Project Address: 1050 E. Washington Avenue
Application Type: Other – Signs in an UDD, Comprehensive Design Review Amendment
Legistar File ID # [70520](#)
Prepared By: Jessica Vaughn, AICP, UDC Secretary
 Matt Tucker, Building Inspection Director

Project Description: The applicant is seeking Final Approval of a Comprehensive Design Review [signage] amendment to allow for additional signable areas above the first floor and for approval of a specific wall sign in Urban Design District No 8.

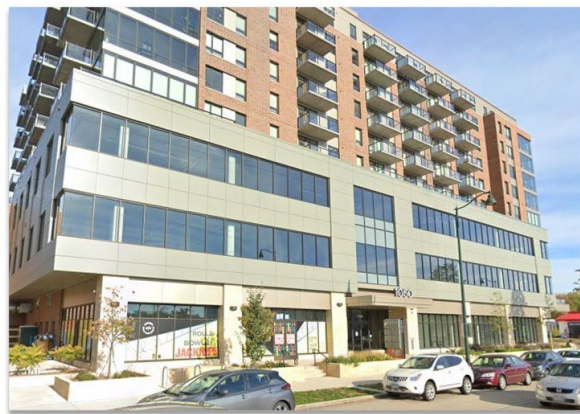
Staff Analysis: Staff has concerns with the shift in sign type as it relates to consistency with both UDD 8 design guidelines and CDR review criteria. While the proposed sign type is among the preferred sign types in UDD 8, original approvals only anticipated wall signage for ground floor tenant spaces. As shown in the Final Approval plans above, projecting signage was anticipated for upper story tenant spaces, in two locations within vertical elements, which resulted in an overall clean, simple building façade and articulation within the building’s vertical elements. As proposed, the wall signage for upper story tenants would increase the overall amount of signage on the building’s front façade. In conjunction with the ground floor tenant spaces, this would result in visual clutter along the building’s street facing façade. In addition, a shift in practice to allow for wall signs as requested may result in similar requests at other properties in the corridor, which currently do not have wall signs above the second story. In at least one case, such an allowance would be a reversal of the UDC’s decision for signage approval (The Constellation).

Similarly, with regard to sign locations or signable areas, the building design does not lend itself to clearly identifiable sign areas other than the three vertical elements on the elevations, two of which were anticipated to host signage. As shown in the Final Approval elevations, the projecting signs were proportional to and centered within the two identifiable sign areas. While the proposed wall signs could certainly be centered within the proposed sign areas noted in the application materials, they are not proportional to the horizontal building element in which they would be mounted.

Overall, staff is not supportive of the shift in sign type. Maintaining the projecting sign type would not only be consistent with original approvals, but also limit sign clutter, potentially improve sign visibility, and also maintain the overall building design aesthetic.

Sign Types within UDD 8

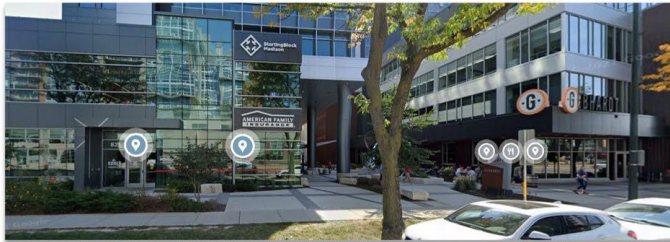
Consideration should be given to the overall design aesthetic and existing context within UDD 8, and the appropriateness of the proposed sign type as it relates to the tenant space, streetscape, and building architecture. As indicated in the site context photos provided above, while various sign types are existing

within the district, new development has primarily utilized window and projecting signage, especially on upper stories.
